3312 Luna - Week of 1/5/26 Update

Here's our weekly update for 3312 Luna Ave:

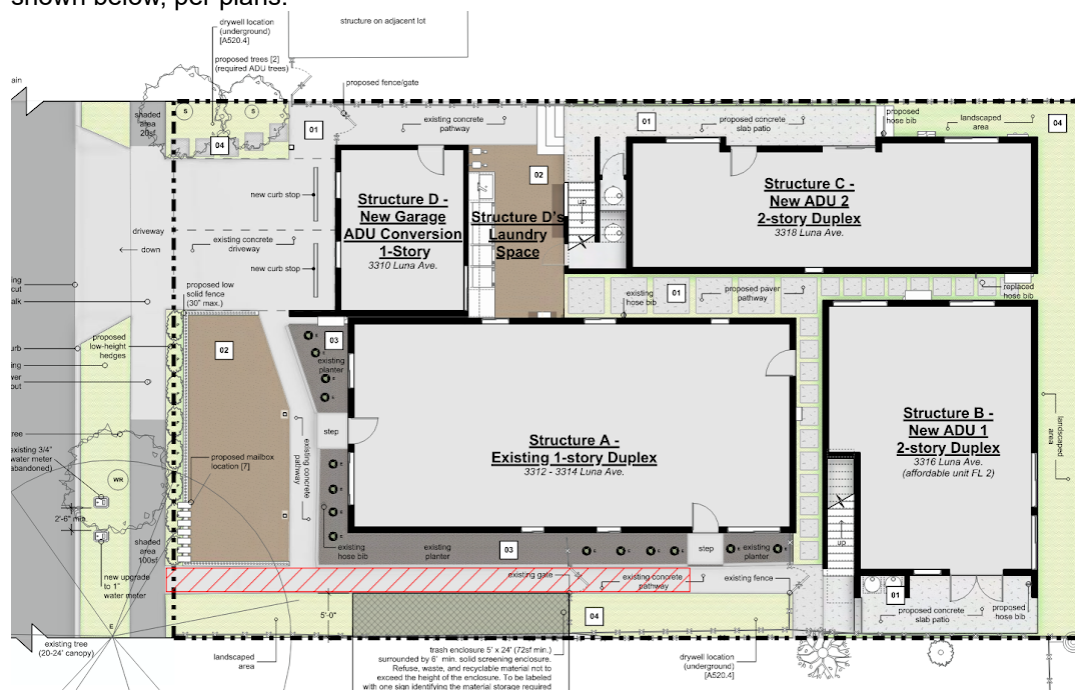
1. I met with the key trades on site yesterday, and everyone is really excited to work on this project. Most of our crew has worked together before, so we anticipate a lot of communication, collaboration and coordination between the trades.
2. The backyard has been cleared of all site concrete, turf, pavers, etc... We are going to try to salvage the area shown below, per plans:

STRUCTURE A ADU-ROOF FRAMING PLAN

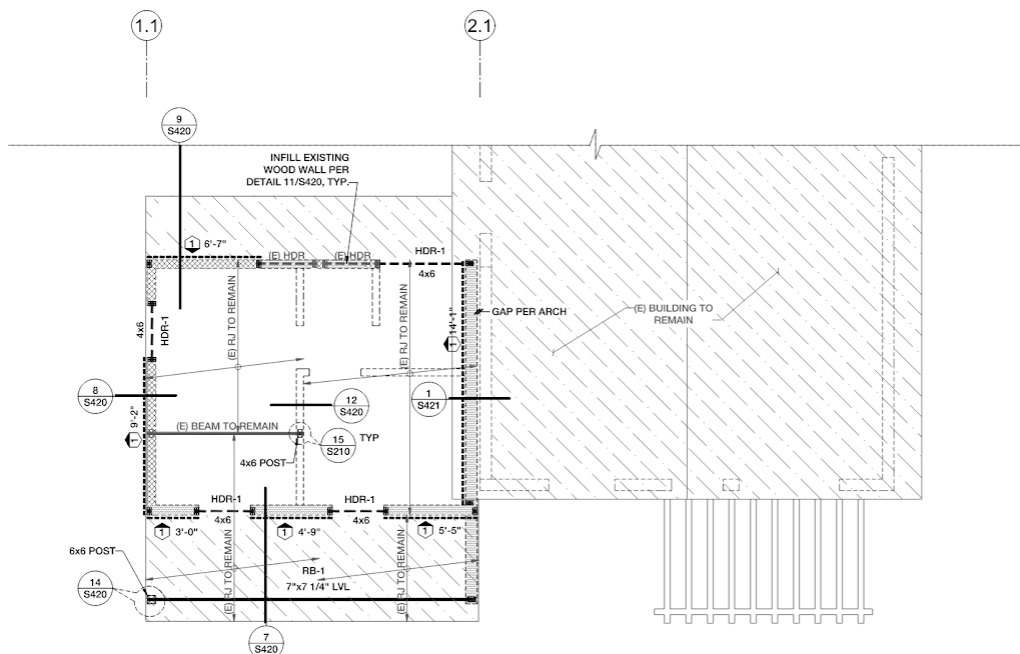
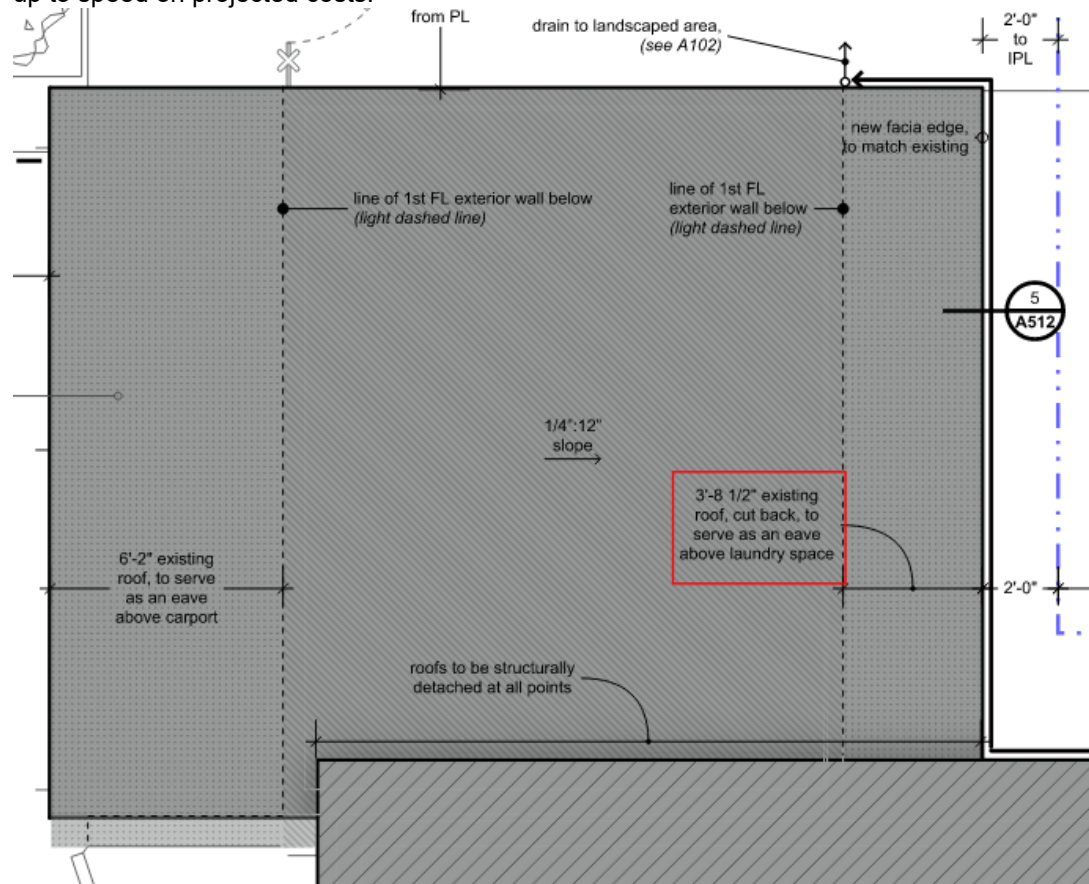
4. The original intent on the laundry area overhang was to cut back the existing roof per the architectural drawings (A211). There is nothing shown on the structural sheets regarding this overhang (S321). Unfortunately, the overhang cannot be built as shown. The joists are not sistered far enough back into the garage to support a 4' cantilevered overhang (see attached photos). We have reached out to 1070 for a revised design and structural detail. Our new plan is to demolish the existing pergola and rebuild the overhang once we have further instructions. Our demo crew has quoted us \$1500, and they will remove the pergola tomorrow or Thursday. This would typically be a change order, as it is a deviation from the plans, but we will make it work within the budget we provided yesterday.

That being said, building back the overhang will be a CO, as framing, roofing, and painting will be affected. I am working with our framer to come up with the most cost effective solution, which I will relay to 1070. I will keep you
